CCD1: Construction Code Determination Form

House No(s) 501 Street Name WEST 30TH STREET
Borough MANHATTAN Block 702 Lot 50 BIN 1012456 CB No. 104

REVIEWED BY
Edwin Tang, RA
Executive Director,
NYC Development Hub
APPROVED
WITH CONDITIONS
Control No. 21502
Date 2/27/12
Page 1 of 8

The Hudson Yards East project consists of multiple building structures that are above a structural platform located on a "super block" between 30th street and 33rd streets bounded by 10th and 11th Avenues in Manhattan, New York. Proposed construction above the platform includes more than 12 million square feet of office, residential, retail and cultural spaces and more than 12 acres of public open space. Tower C is one of several towers proposed as part of the Hudson Yards project.

HYE-KPF-SKT-A-20111206 TOWER C

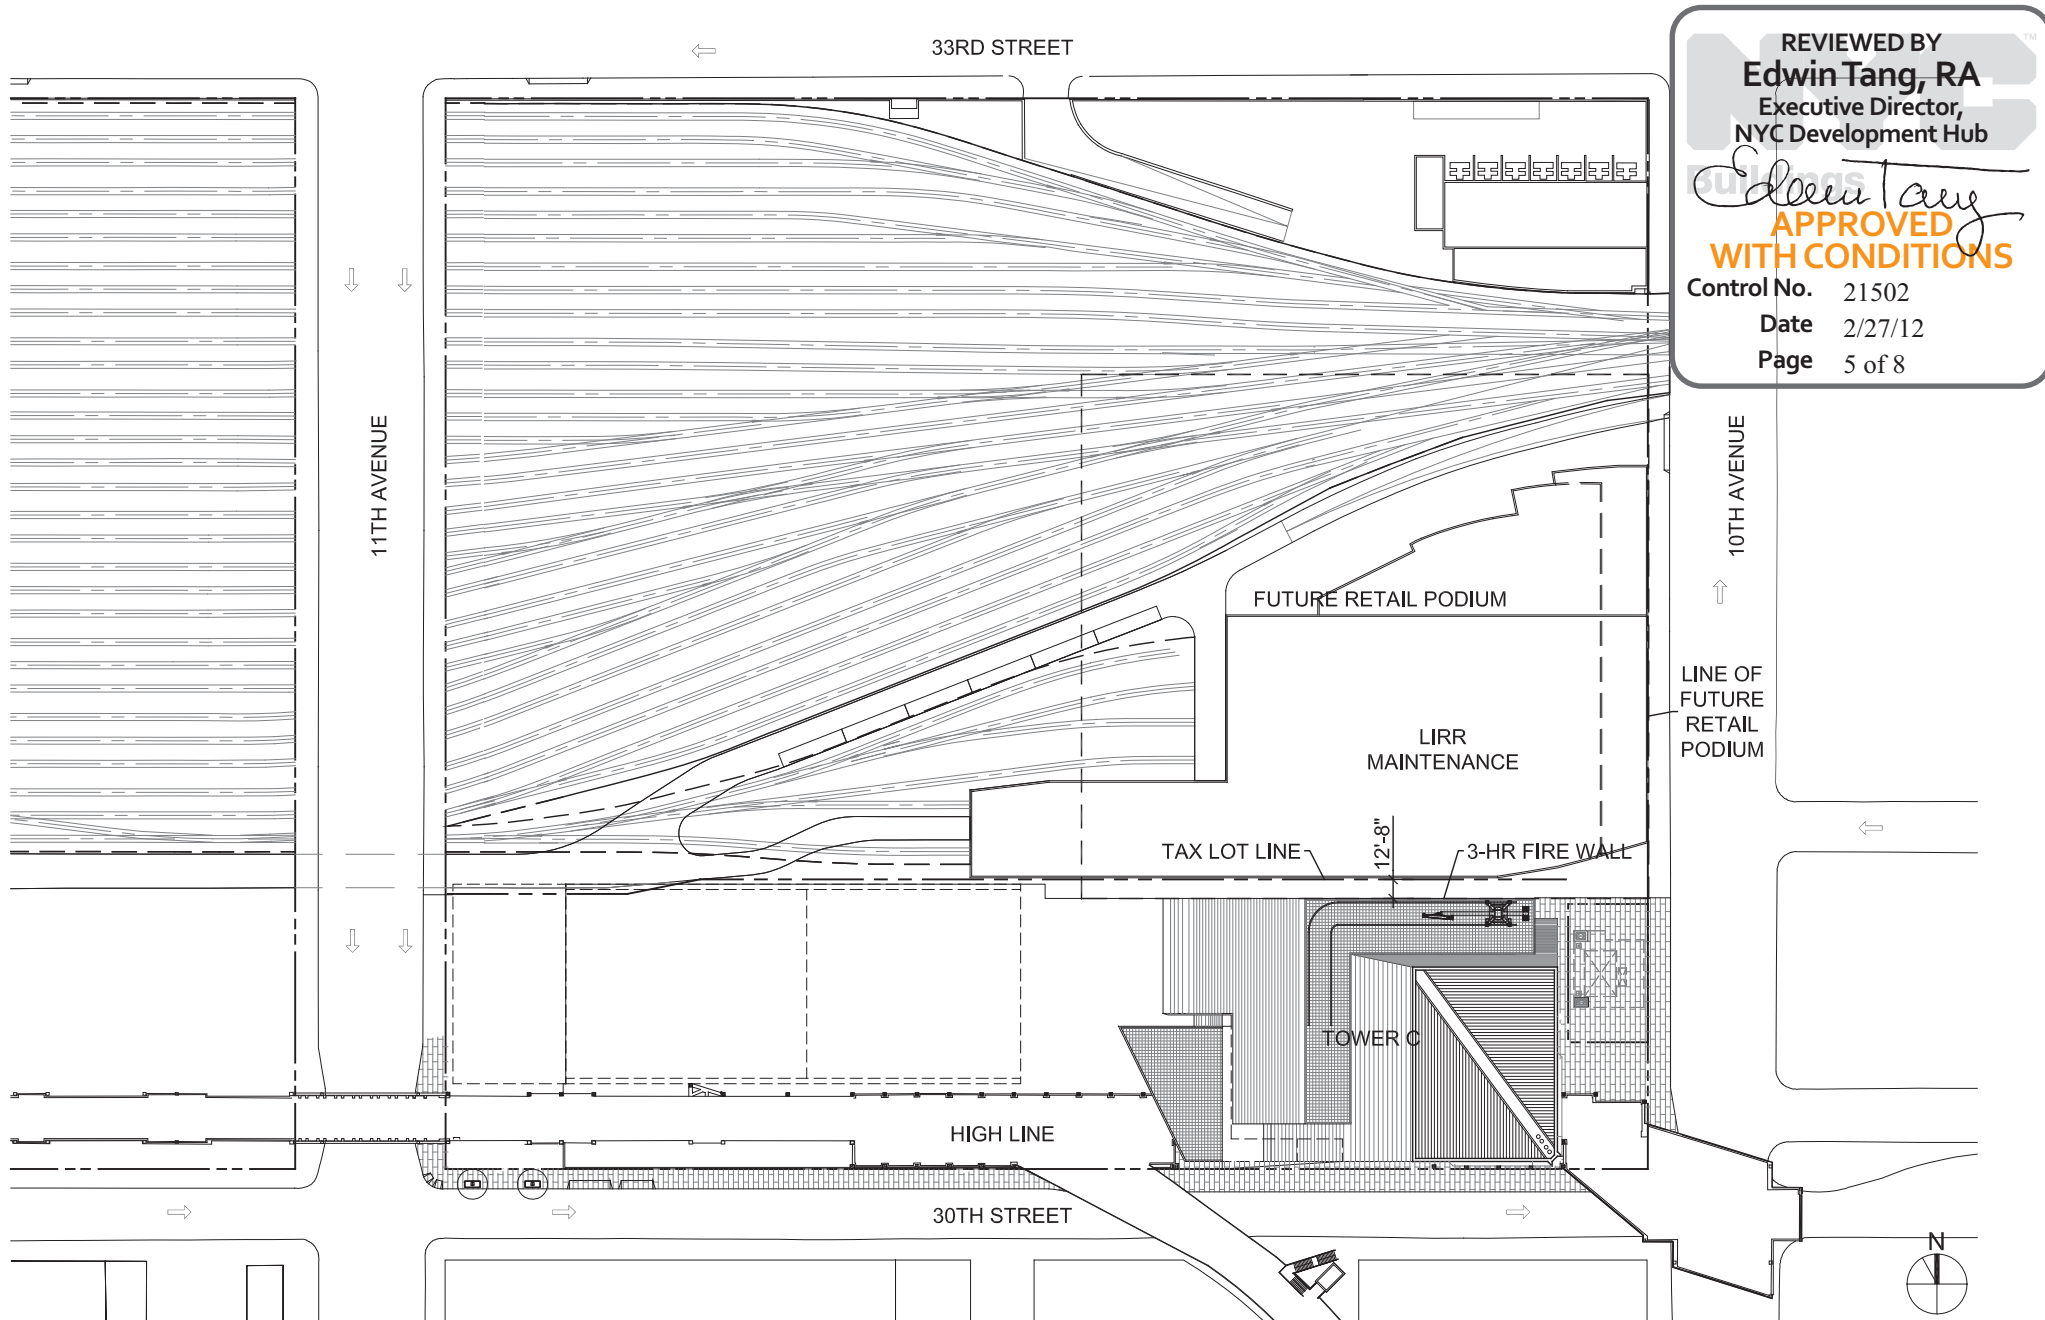
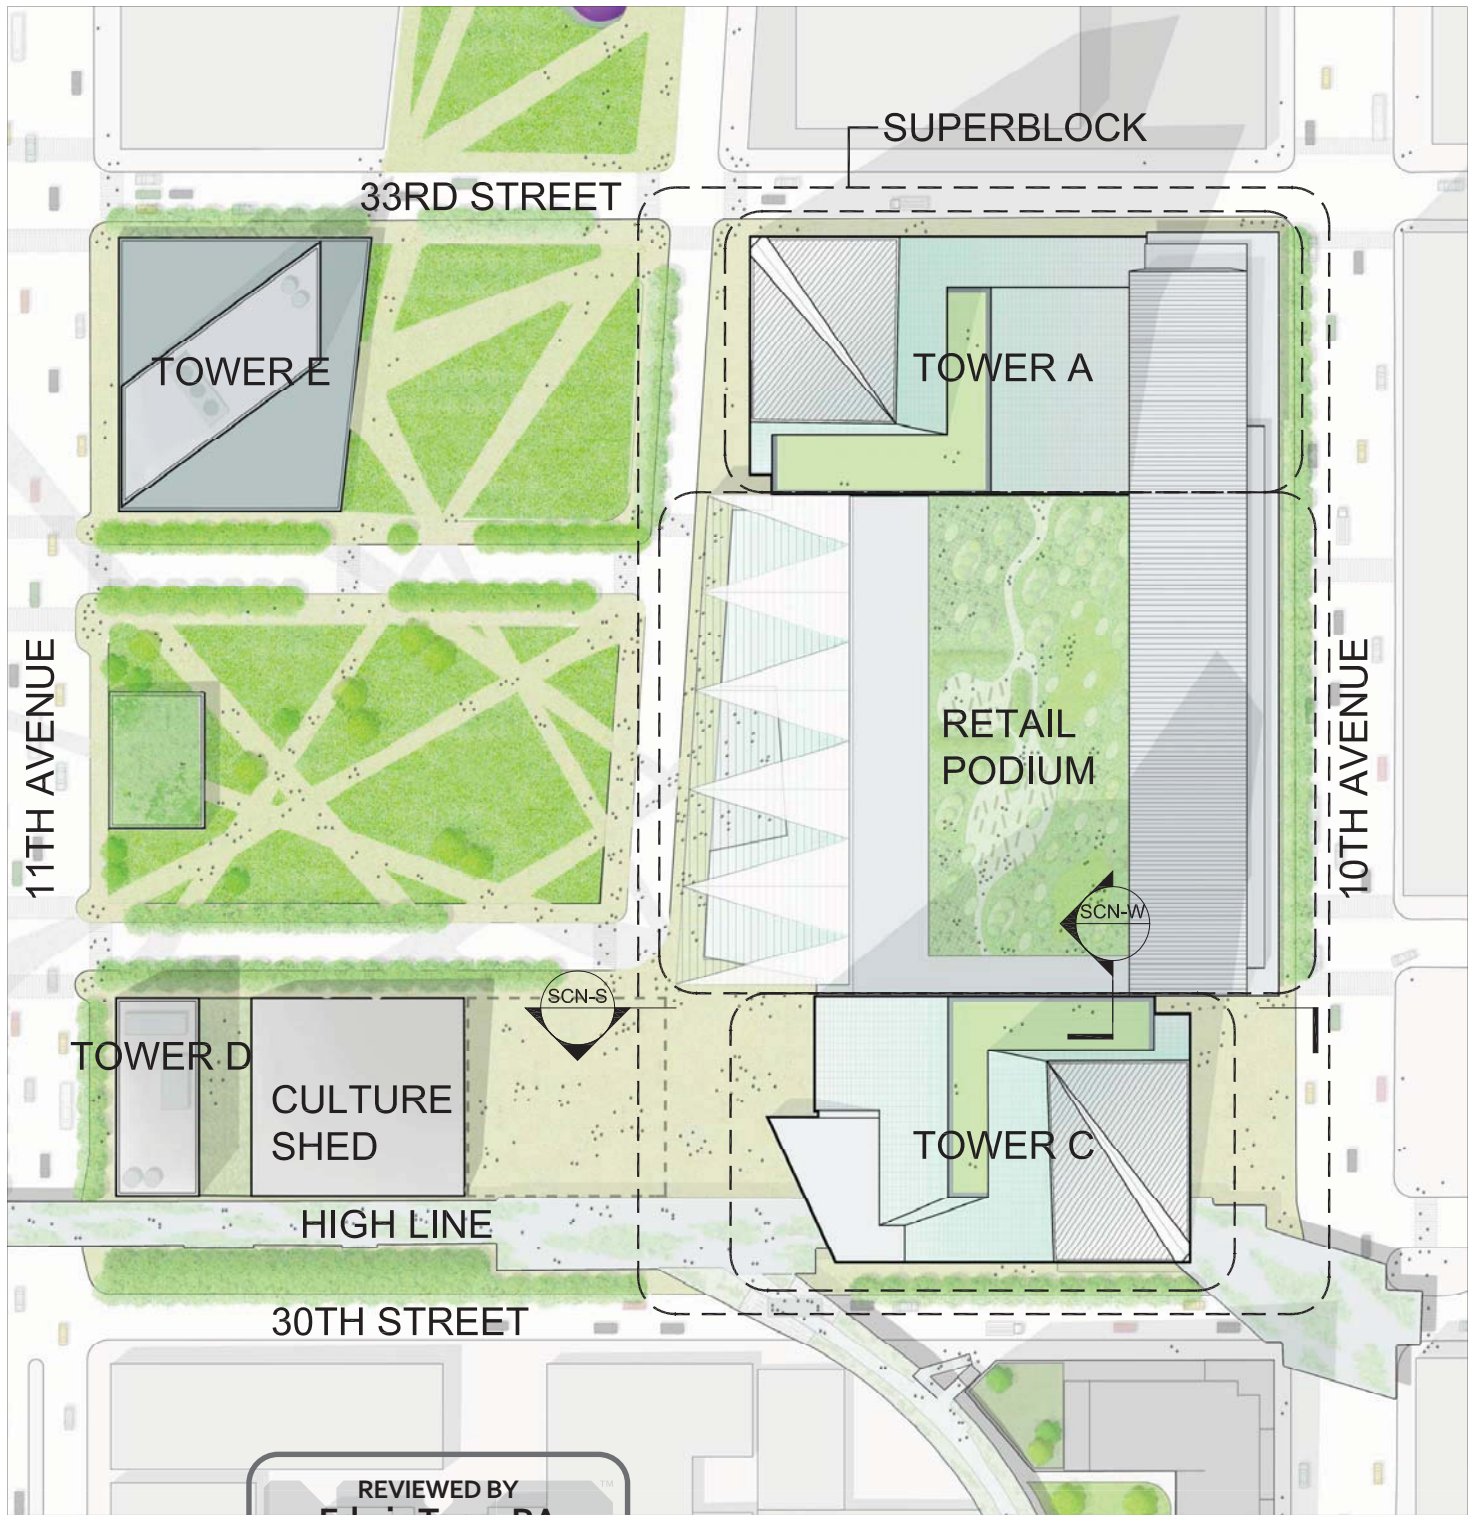
To maintain the separate building approach, a 3-hour fire wall complying with Section 705 will be constructed at the zero lot line for the six podium levels. A determination is requested to permit openings in excess of Table 704.8 for openings in Tower C above the fire wall. It is proposed to have typical window openings without limitation for the north façade above the podium levels.

Building Code Section 704.10 permits unprotected openings above the fire wall provided that the roof of the adjacent building is fire resistance rated for a minimum distance of 10 feet horizontally and that the buildings are located on the same tax lot. As discussed above, the "super block" will be owned and developed by one developer similar to when multiple buildings are constructed on single tax lot. Therefore, the developer will ensure that the roof of the adjacent podium will be a minimum 1-hour fire resistance rated which reduces the potential for fire exposure from the Podium. Additionally, the code permits exterior wall openings to exceed the limits outlined in Table 704.8 when the openings are greater than 60 feet (in a direct line) from a separately neighboring building. Therefore, the code would permit openings above 60 feet to exceed the limits outlined in Table 704.8. Therefore, the determination is required for the openings in Tower C within 60 feet of the Podium.

The request to allow openings on the north exterior wall of Tower C in excess of the limitations set forth in Table 704.8 is hereby approved with conditions:

1. Openings located on the north exterior wall that are beyond a distance of 60 feet measured in a direct line to any neighboring building may be unlimited and need not be protected, and shall be recorded by restrictive declaration in accordance with Buildings Bulletin 2008-007 with CRFN noted on the certificate of occupancy of the new building with agreement to close the openings on such exterior walls with construction meeting the prescribed fire resistance rating requirements pursuant to Tables 601 and 602 should such 60 feet distance ever be compromised, in accordance with Table 704.8, footnote (L); and

2. Openings on floors of the north exterior wall within a distance of 60 feet in a direct line from any neighboring building shall comply with the limitations based on fire separation distance as set forth in Table 704.8.

It shall be noted, however, that an exterior wall assembly consisting wholly or in part of inoperable glass is not considered an opening in such exterior wall provided that such wall assembly is tested to meet the required fire rating for exterior walls pursuant to Table 601 and 602 of the 2008 Building Code.

HYE-KPF-SKT-A-20111206 SITE PLAN

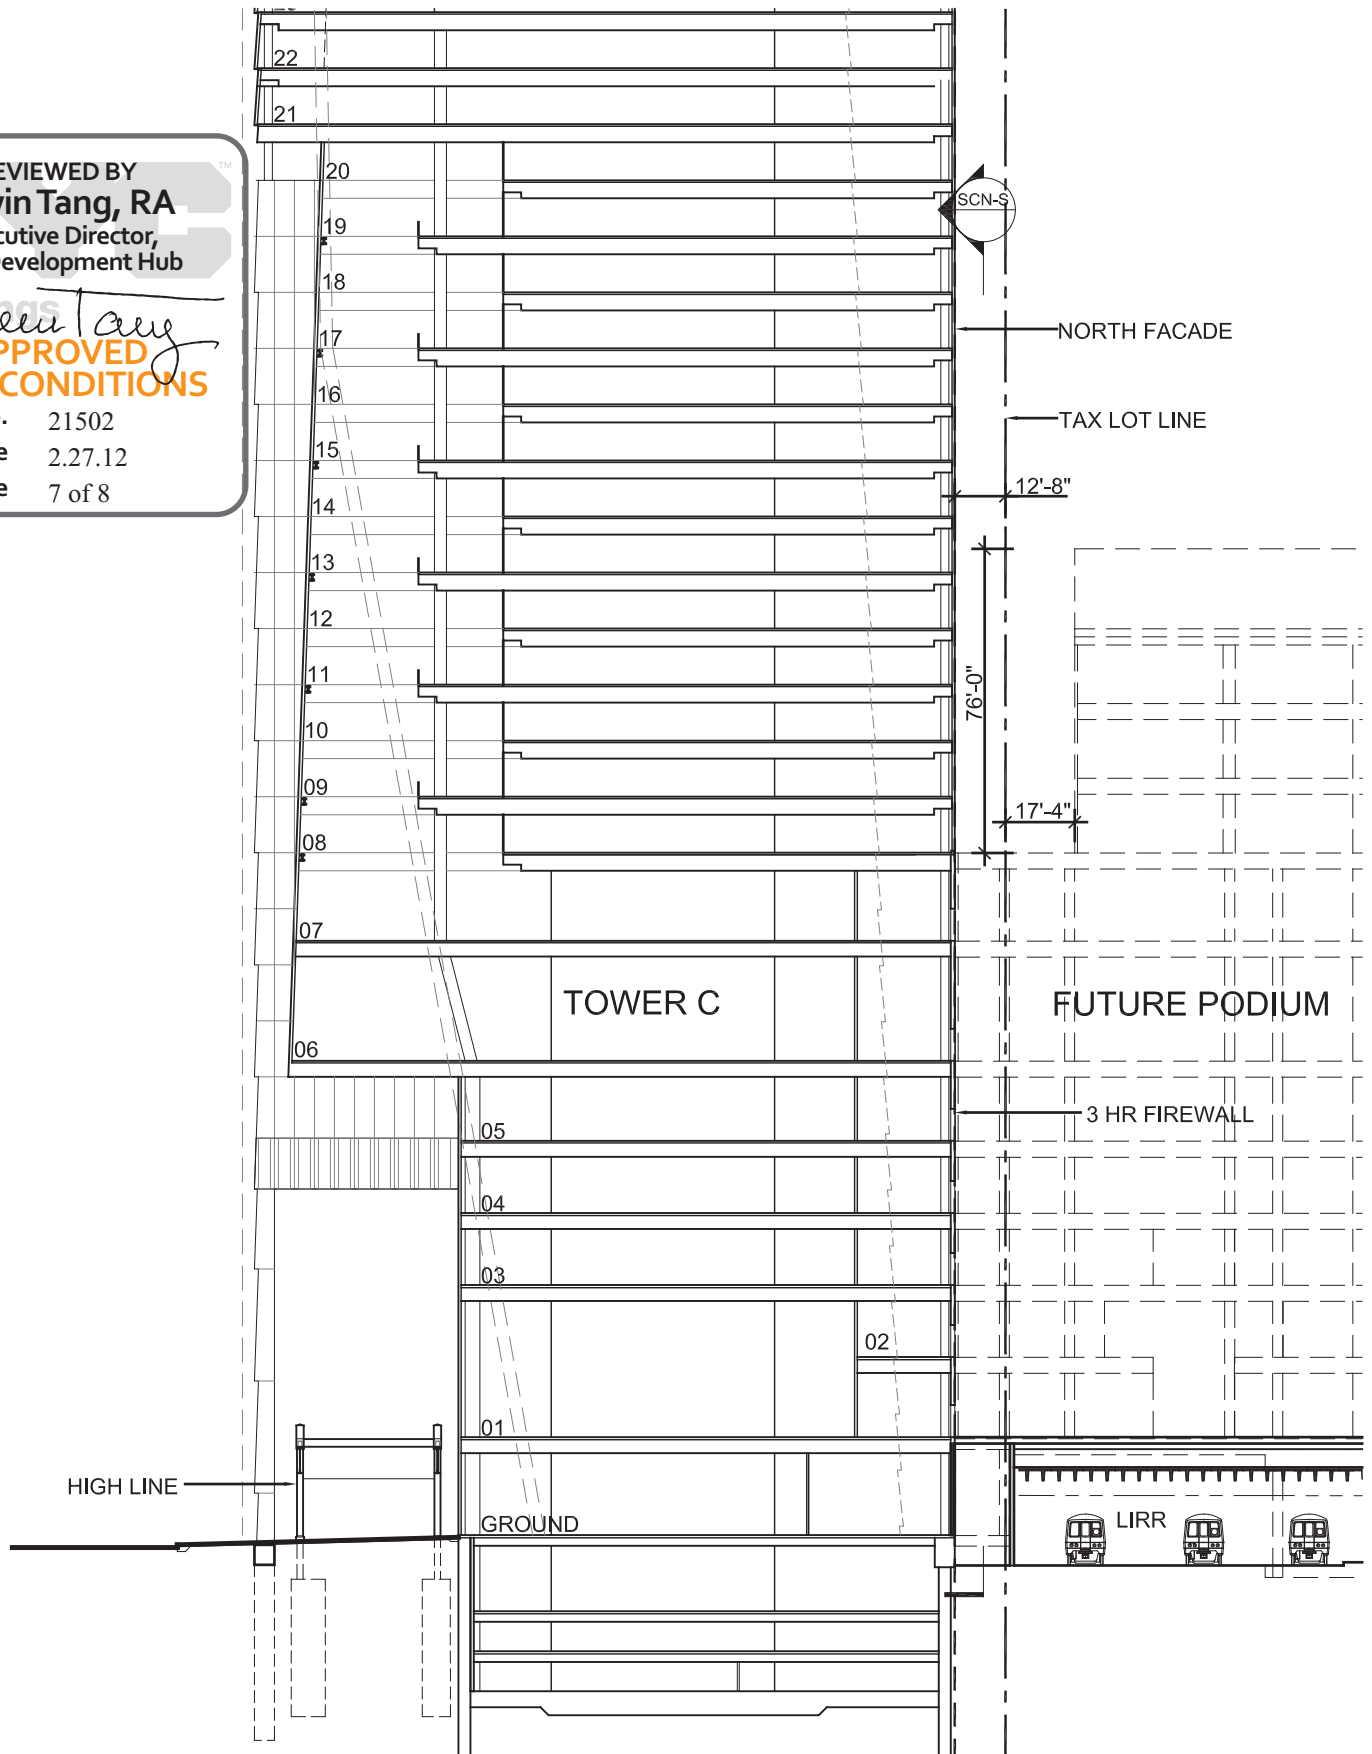
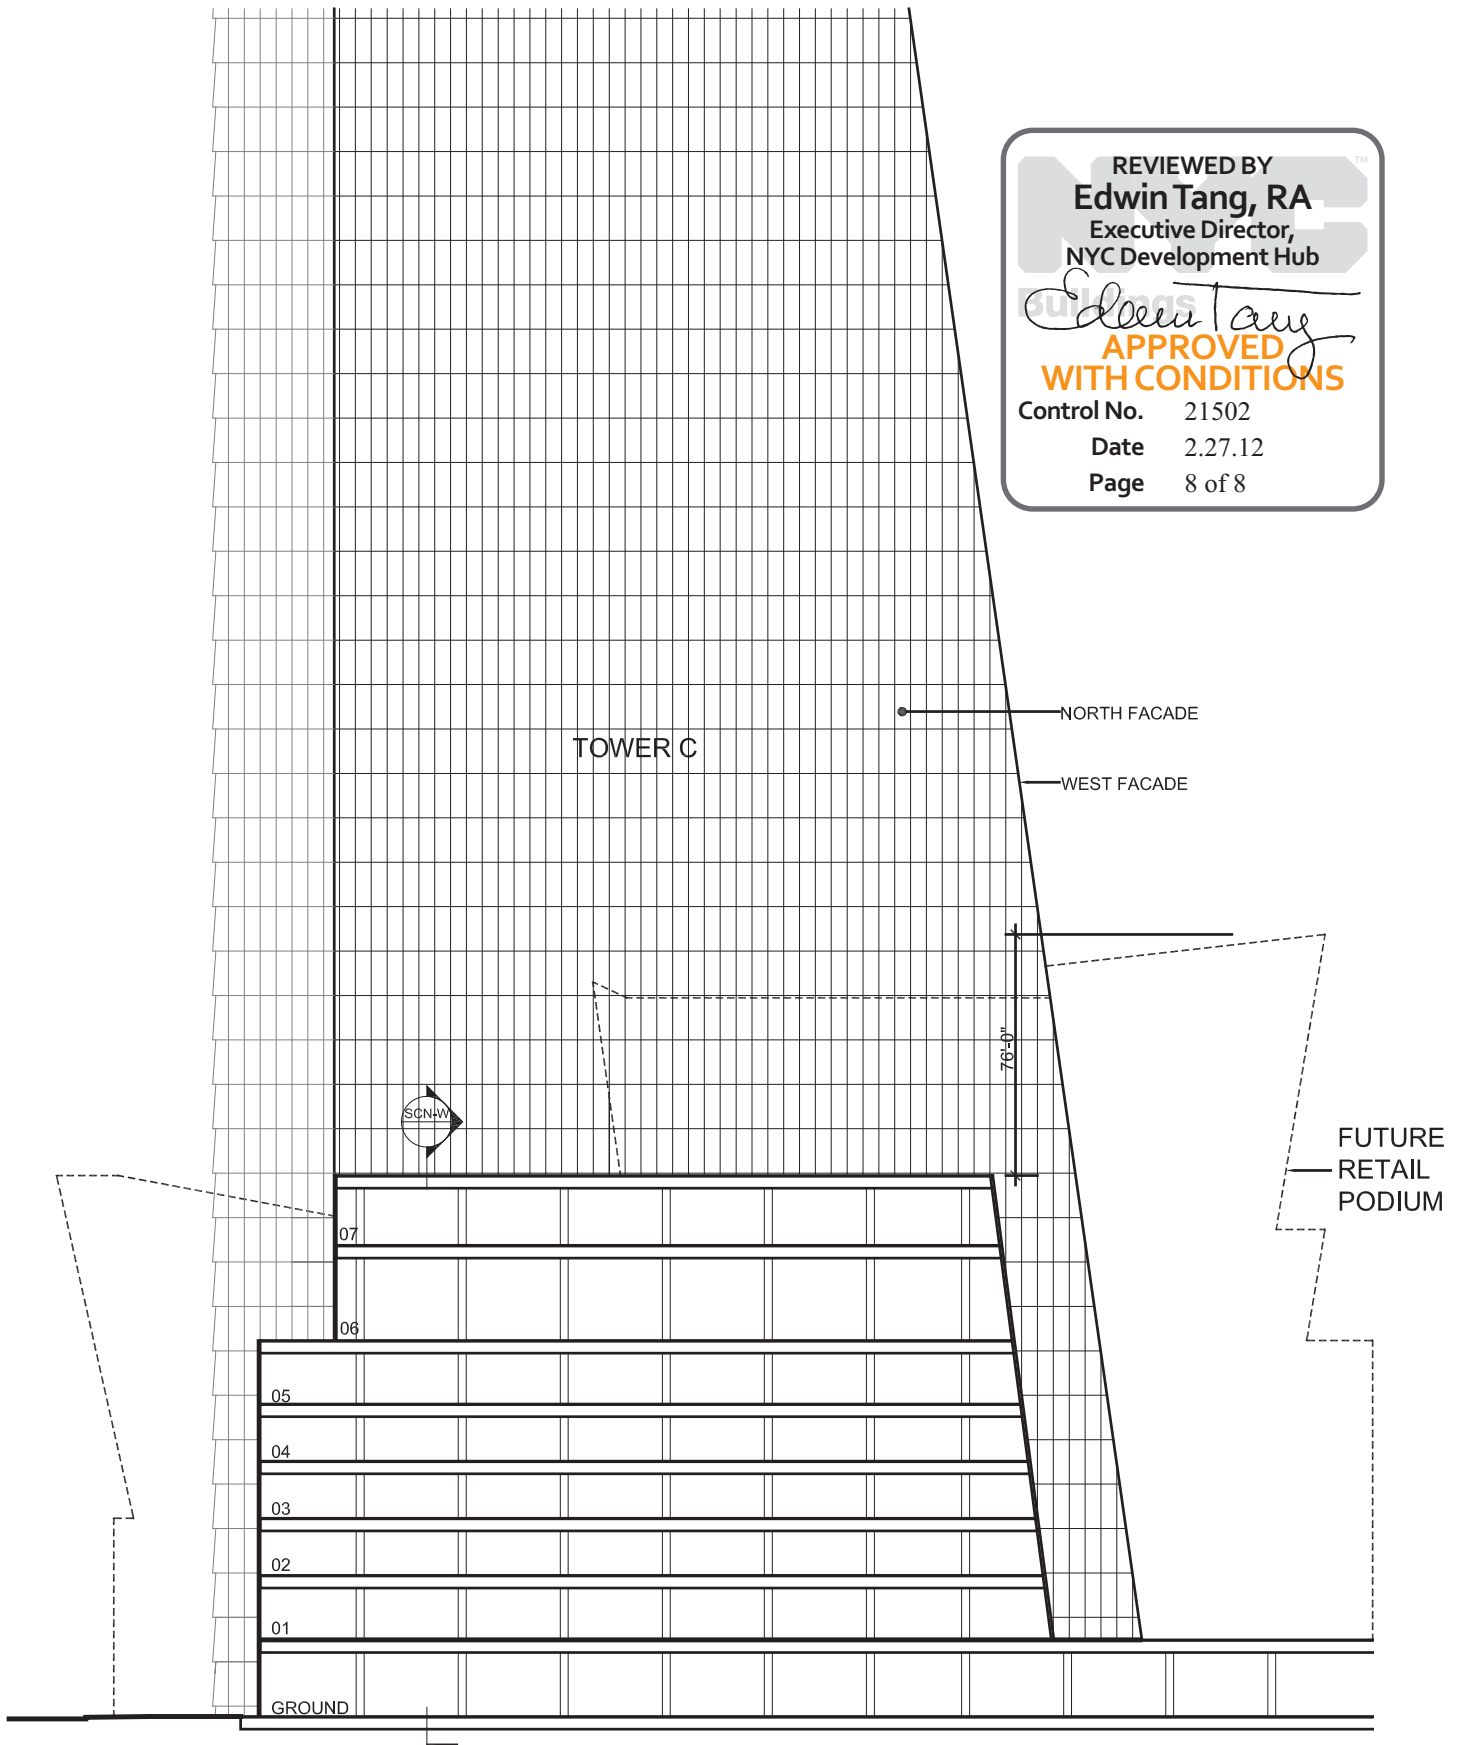
The "super block" is owned and is being developed by a single developer. The developer is creating separate tax lots for the purposes of phased construction due to the size of the project. See attached site plan.

The north facade of Tower C is located 12ft-8in from the tax lot line. Therefore, the exterior walls are required to be 1-hour fire resistance rated and are permitted 45 percent openings per level. In the future, an easement will be pursued and the Podium building will be constructed immediately adjacent to Tower C (infilling the 12 feet from Tower C to the tax lot line).
